ADA Curb Ramp New Construction Inspection Form (Perpendicular)

Nw287

24952.54

Nw may

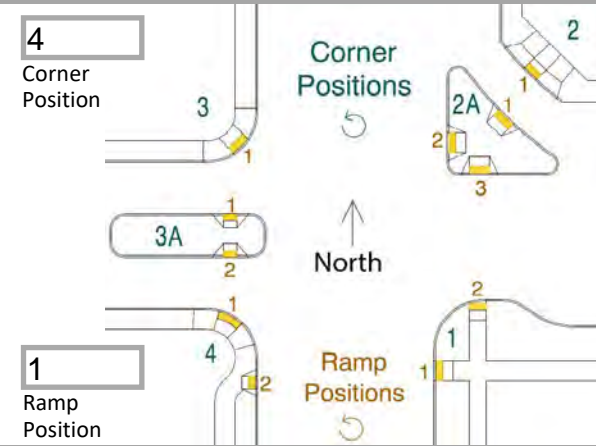
ICRR, DIFFERENTIAL SETTLEMENT
RR1/TS Crack
